# HS2

Warwick District Council

Dalehouse Embankment and Finham Brook Viaduct  
Schedule 17 Plans and Specifications Written  
Statement for Information

WAC.PS.10022

Table 9: Comments Raised by WDC During the Pre-Application Period and the Applicant's Response

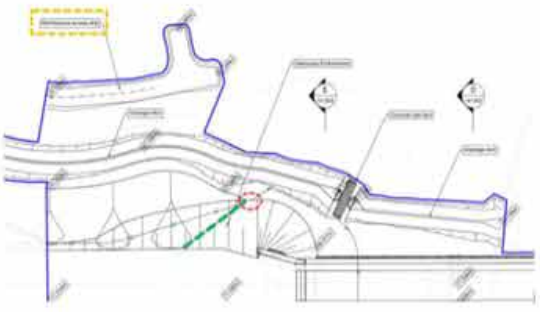
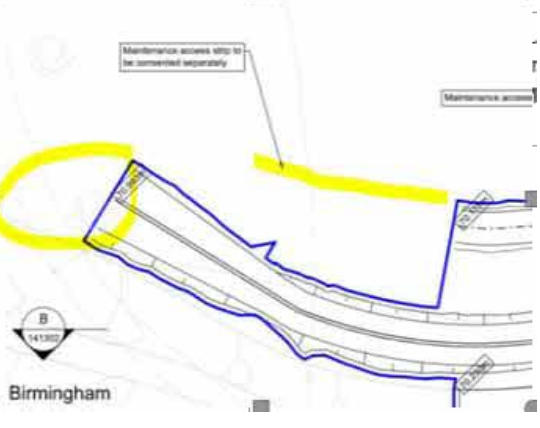
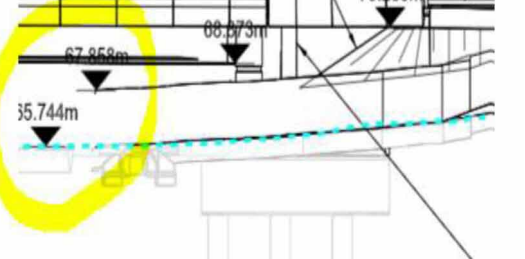
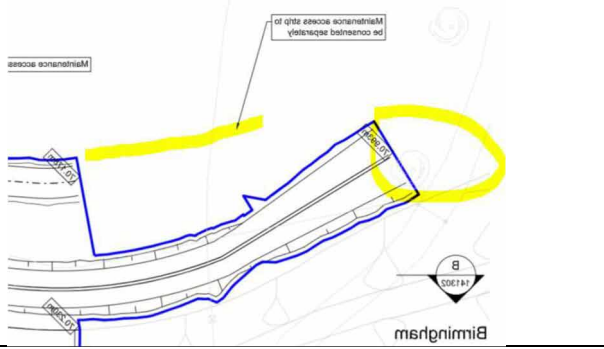
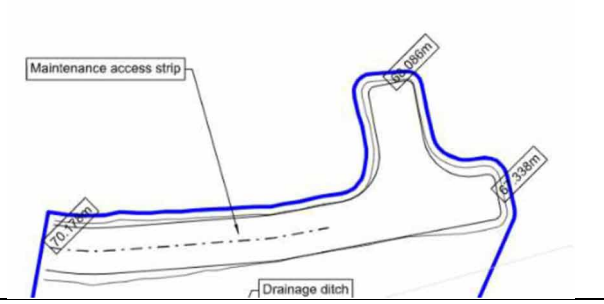
WDC Comment	Applicant Response
<p>Align hatch to drawing where necessary</p> 	<p>As far as is possible the draughting error identified in the LEMP has been updated. (See drawing ref: 1MC08-BBV_MSD-PL-DGA-NS01_NL03-141305).</p> <p>The LEMP is indicative and provided for information only. Final details regarding planting and all mitigation will be provided at the bringing into use stage.</p> <p>An updated LEMP is going to be produced for Dalehouse Embankment and any outstanding draughting errors will be amended in the updated LEMP.</p>
<p>Hatch over what looks to be turning head? Can the size of this be reduced to what is absolutely necessary, and can it be labelled with the material indicated. Permeable surface without edging? Need for a threshold with a consolidated surface</p> 	<p>An updated LEMP is going to be produced for Dalehouse Embankment but in the interim the LEMP has been revised so that the hatch isn't shown over the turning head. (See drawing ref: 1MC08-BBV_MSD-PL-DGA-NS01_NL03-141305).</p> <p>The 3m width of the maintenance access strips is what is required in the HS2 access technical standard. The turning head / parking bay is also designed to allow a vehicle to turn and therefore cannot be smaller.</p> <p>Maintenance access strips made from grass or topsoil are the required form of access in accordance with the HS2 Access technical standard. There is no requirement for stone or other similar materials for accesses that will be only occasionally used.</p>

<p>Generally hatching over areas which shouldn't be across the drawing.</p>	<p>A label has been added to the LEMP (drawing ref: 1MC08-BBV_MSD-PL-DGA-NS01_NL03-141305) to clarify that the landscaping is below Finham Brook Viaduct in this location. Please note that the LEMP is a draft drawing, provided for information and is not for approval. Final details regarding planting and</p>

<p>all mitigation will be provided as part of bringing into use application.</p>
<p>Scalloped security fence line. Also crossing viaduct could this be greyed or labelled that it is underneath for clarity.</p>	<p>A label has been added to the GA drawing (ref: 1MC08-BBV_MSD-PL-DGA-NS01_NL03-141301) to clarify that the security fencing goes underneath Finham Brook Viaduct in this location.</p>
<p>Landscape and Engineering earthworks hachure overlap. Spot heights need reference points.</p>	<p>The GA drawing has been updated (see drawing ref: 1MC08-BBV_MSD-PL-DGA-NS01_NL03-141301). The landscape and engineering earthworks hachure no longer overlap in the drawing and spot heights now have reference points.</p>
<p>Purpose of line highlighted in green is unclear; best removed? Continuation of fence in the red area is unclear; avoid awkward angles? Maintenance access strip – is this as narrow as possible? Permeable surface without edging? Permeable soil retention systems are preferred for hardstanding/parking areas</p>	<p>The GA drawing has been updated (see drawing ref: 1MC08-BBV_MSD-PL-DGA-NS01_NL03-141301). The line indicates the point where the landscape earthworks connects with the engineering earthworks.</p>

<p>line appears missing, and needs a label</p> 	<p>The GA drawing has been updated and now shows wider context in grey (see drawing ref: 1MC08-BBV_MSD-PL-DGA-NS01_NL03-141301).</p>
<p>Why not continuous:</p> 	<p>The elevation drawing has been updated (drawing ref: 1MC08-BBV_MSD-PL-DEL-NS01_NL03-141302).</p>
	<p>The elevation drawing has been updated (drawing ref: 1MC08-BBV_MSD-PL-DEL-NS01_NL03-141302).</p>
<p>Drawings have been provided to accompany this submission which identify that the embankments will have soft slopes to reduce the visual impact of the assets. At application stage it is considered that additional context to the plan (shown in grey) to show how the earthworks connect to the wider landscape would assist in the determination of the eventual Schedule 17 submission. In particular, it would help if the drainage ditch continuations and continuation of the maintenance access track outside the blue line are shown for clarity. This is</p>	<p>The GA drawing has been updated and now shows the wider context in grey including the continuation of the drainage ditch and the maintenance access strip.</p>

<p>beneficial to Officers during assessment and also to anyone viewing upcoming documents publicly.</p> 	
<p>Junction here with greyed works looks o .</p> 	<p>This is amended in the updated GA drawing (ref: 1MC08-BBV_MSD-PL-DGA-NS01_NL03-141301).</p>
<p>Material of access strip to be labelled on drawing ideally, turning point size to be no more than necessary.</p> 	<p>Grass is proposed on the maintenance access strip, and this is now labelled on the GA drawing. The maintenance access strip is 3m wide which aligns with the HS2 access technical standard and therefore cannot be reduced. The turning head is also designed to allow a vehicle to turn and therefore cannot be smaller.</p>
<p>At application stage it is considered that a additional context to the plan (shown in grey) to show how the earthworks connect to the wider landscape would assist in the determination of the eventual Schedule 17 submission. In particular, it would help if the drainage ditch continuations and continuation of the maintenance access track outside the blue line are shown for clarity. This is beneficial to Officers during assessment and also to anyone viewing upcoming documents publicly.</p>	<p>The GA (ref: 1MC08-BBV_MSD-PL-DGA-NS01_NL03-141301) has been updated and wider context is now shown in grey.</p>

<p>Security fencing is shown, though there are some concerns raised over the illustration of this on the drawings, as it appears scalloped in plan and interrupted in elevation. This should be resolved before application submission. The location of the</p>	<p>The proposed fence is a type 3 security fence. The type 3 fence comprises of a protective coated 1.8m high welded mesh fencing with three strands of barbed wire above (total height of 2.13m) in accordance with BS 1722-</p>

<p>fencing should be kept as tight to the embankment as is feasible, with tree planting outside of the fence line, and awkward angles should be avoided to keep the footprint and impact of visibly disruptive elements to the absolute minimum. The General Arrangement drawing would also benefit from labelling at the Viaduct to indicate that the fencing passes underneath.</p>	<p>14. A label is included in the GA to indicate that the fencing passes underneath Finham Brook Viaduct.</p>
<p>With respect to the landscape proposals, it is acknowledged these are indicative. However, they seem somewhat inaccurate and there are some draughting errors which have been raised in previous correspondence. Most notably, woodland planting is shown over the maintenance access routes, immediately abutting the top edge of the railway embankments and overlapping the course of Finham Brook.</p>	<p>As far as is possible the draughting errors identified in the LEMP have been updated. Woodland planting is no longer shown over the maintenance access strips. The LEMP is indicative and provided for information. Final details regarding planting and all mitigation will be provided at the bringing into use stage.</p>

<p>The Landscape Officer has made comments raising concern over the access tracks, as they appear unnecessarily wide. There are two maintenance accesses in close proximity to each other; the question is posed whether these could be rationalised into a single access, so justification or reasoning as to why this is not the case should be given. Similarly, some of the turning areas and bellmouths seem too large for their purpose. All tracks and turning areas should be as narrow and small in scale as possible.</p>	<p>The maintenance access strip is 3m wide which is in accordance with the HS2 access technical standard and therefore cannot be reduced. The turning head is designed to allow a vehicle to turn and therefore cannot be smaller. The MAS and the associated turning head / parking bay will be used only for HS2 maintenance purposes at a low frequency and will have no impact on road safety. The MAS's cannot be rationalised into a single access despite their close proximity because maintenance access is required on both sides of the rail tracks for maintenance purposes.</p>

As far as is possible, the LEMP (drawing ref: 1MC08-BBV\_MSD-PL-DGA-NS01\_NL03-141305) has been updated to resolve general draughting errors. Note that the LEMP is a draft drawing provided for information and is not for approval. Final details regarding planting and all mitigation will be provided at a later stage.

Drawings - The GA, elevations, sections and LEMP have been updated in line with the latest drawing guidance.
